Midway City Council
16 July 2019
Regular Meeting

Cozens Subdivision /
Preliminary & Final Approval

CITY COUNCIL MEETING STAFF REPORT

Subject: Cozens Subdivision, – Preliminary / Final Approval

COZENS SUBDIVISION PLAT - 8 APRIL 2019

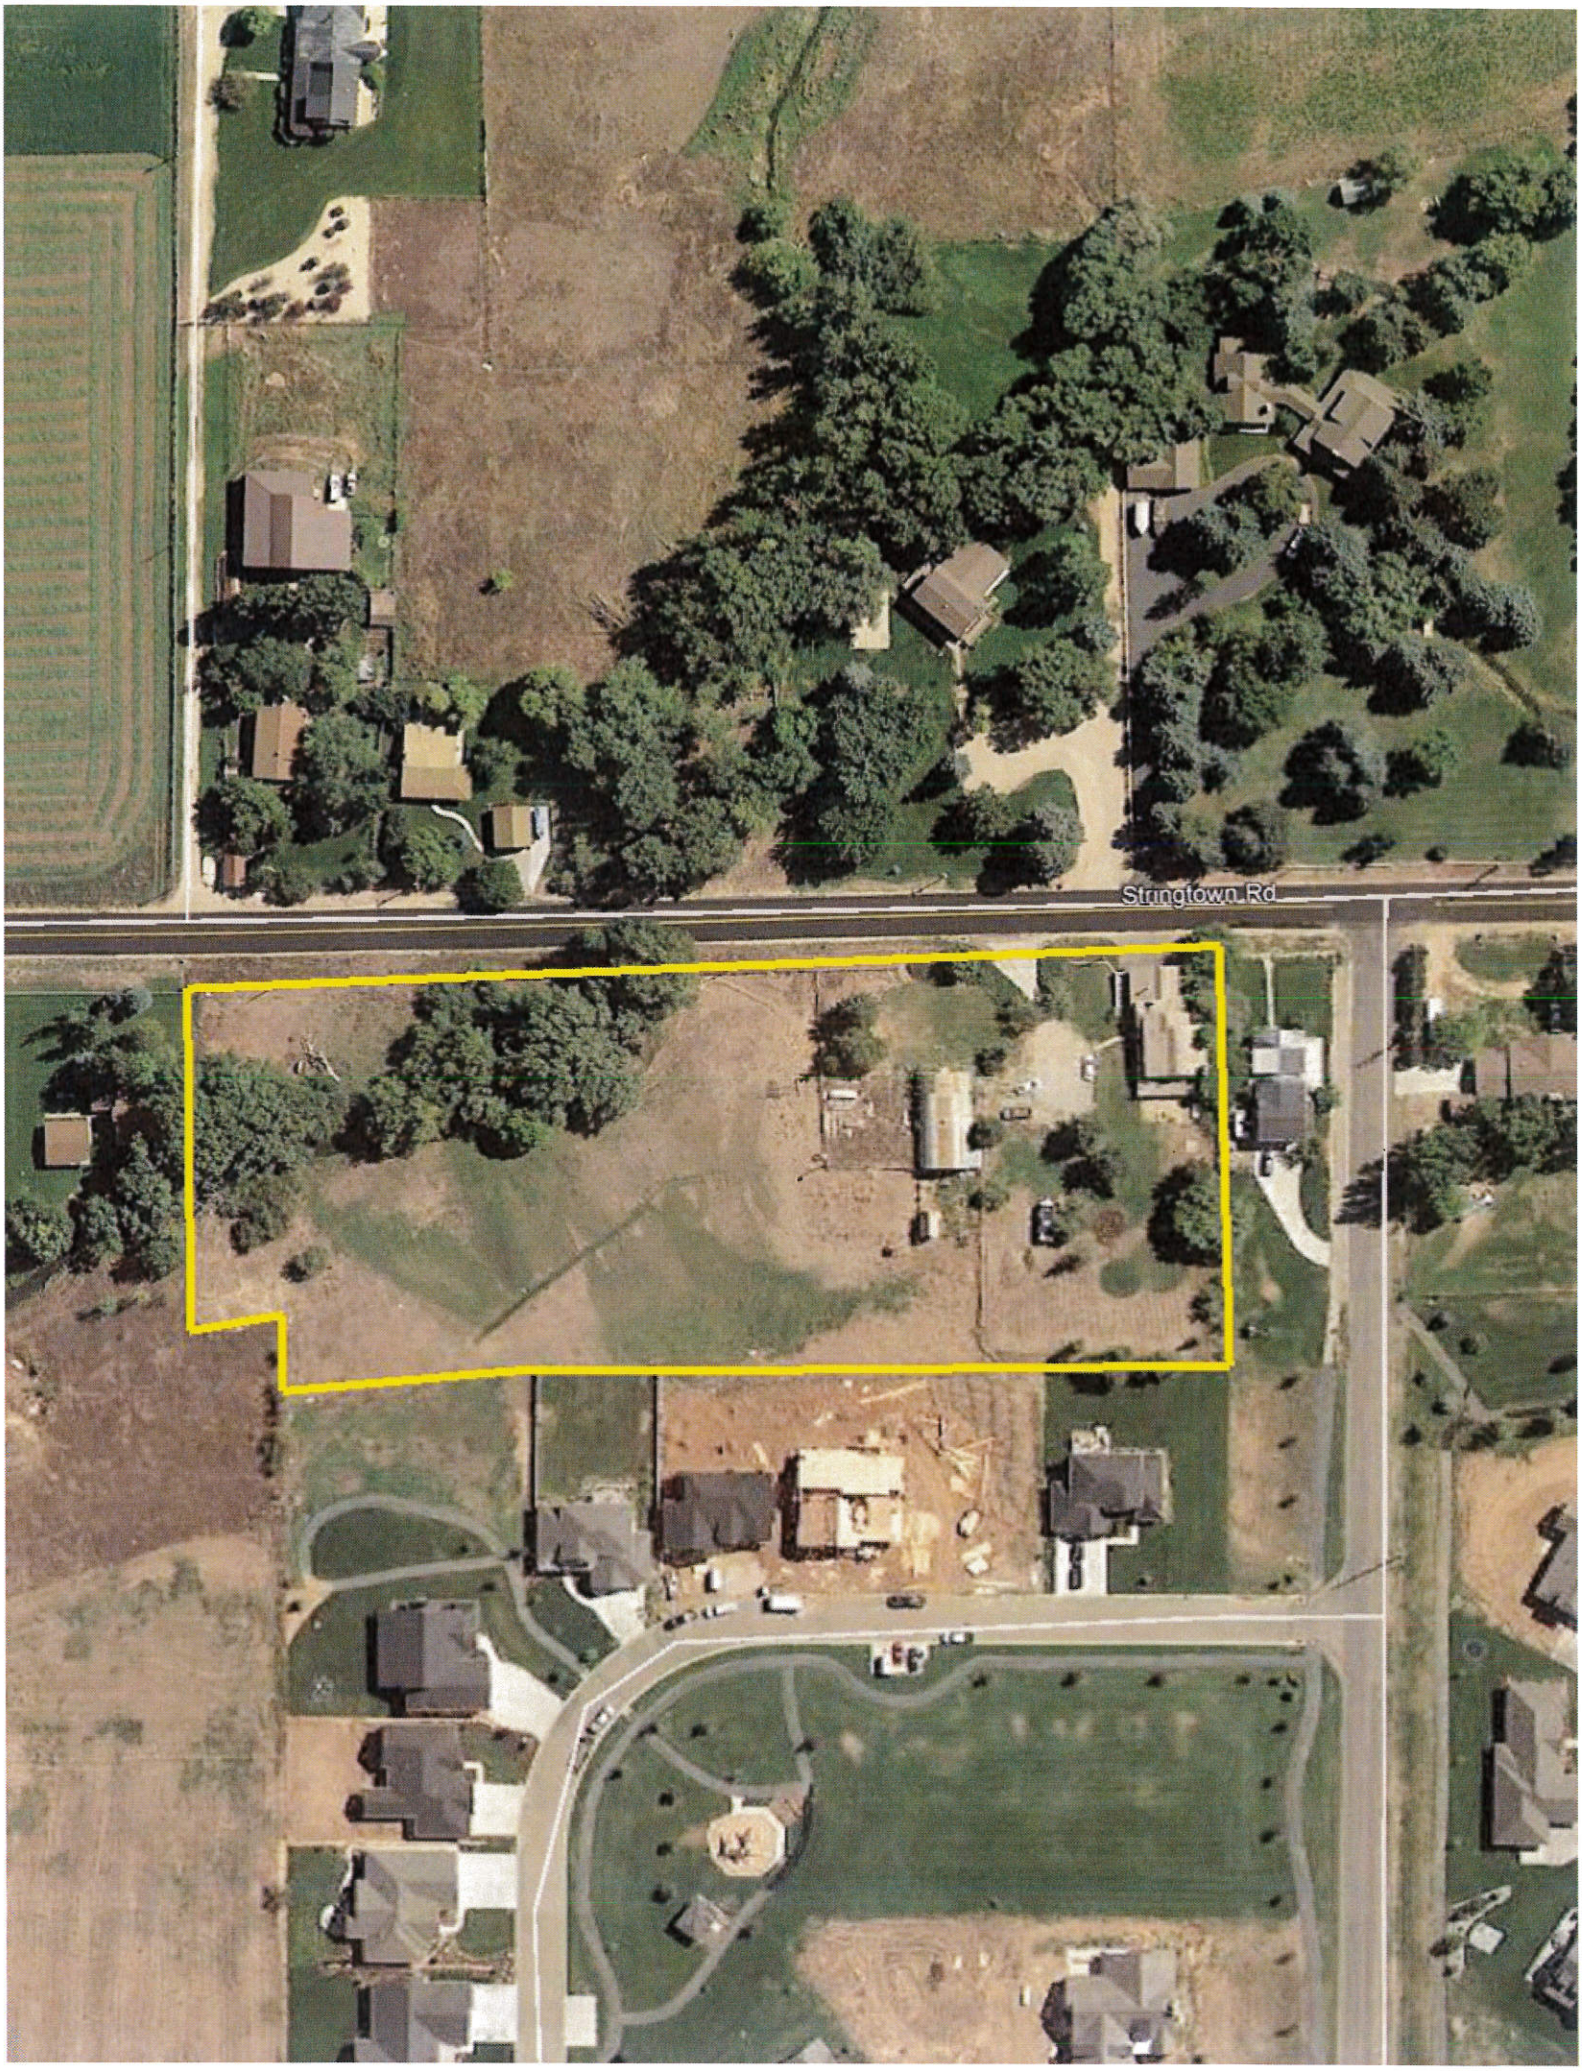
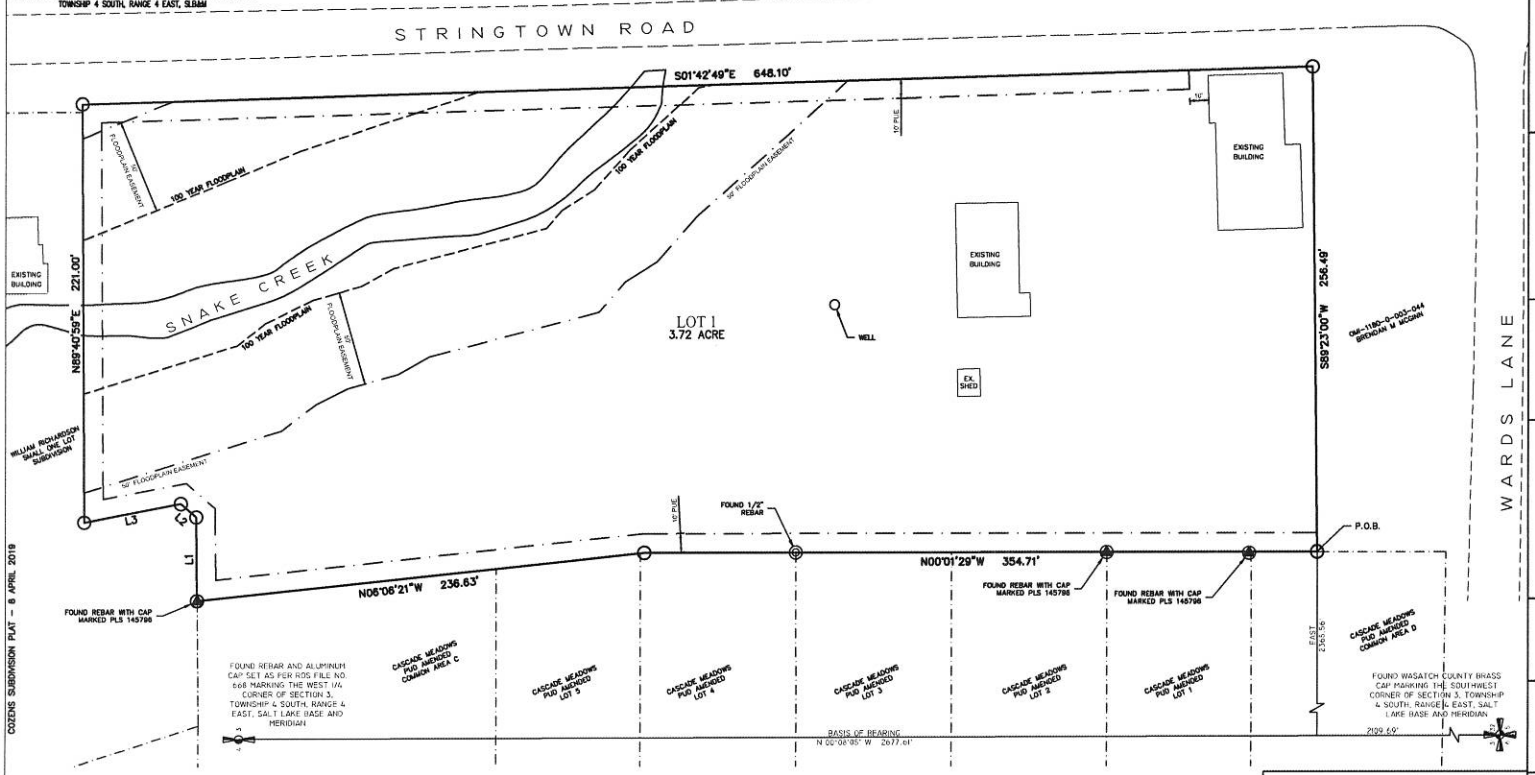
There are sensitive lands present on the property. Snake Creek runs through the northeast section of the property. A FEMA floodplain accompanies Snake Creek which requires a 100' setback or any structures. The submitted plans do show the floodplain with the required 100' setback.

Sensitive lands – Snake Creek runs through the property and has a FEMA floodplain associated with it. A 100' setback is required for all structures from the FEMA floodplain which will be shown on the plat limiting where future structures may be located.

Setbacks – A 50' setback is required for any structures built in the proposal. The required setback will be noted on the plat.

Horrocks Engineers recently reviewed the Cozens Subdivision plat for Preliminary and Final approval. The proposed subdivision is located at approximately 840 South Stringtown Road. The proposed subdivision consists of 1lot. The following issues should be addressed.

- The small scale subdivision is not proposing to construct any new roads or public infrastructure. If the plat is further subdivided, the existing sewer line at the intersection of Stringtown Road and Wards Lane should be extended to the North boundary of the subdivided plat.

- The existing home is served by the existing 10" water line within Stringtown Road.

- The existing Stringtown Road shoulder will contain the storm water.

1. The living space in the barn is removed or the applicant can show that the living unit was approved by Wasatch County before final approval is granted.
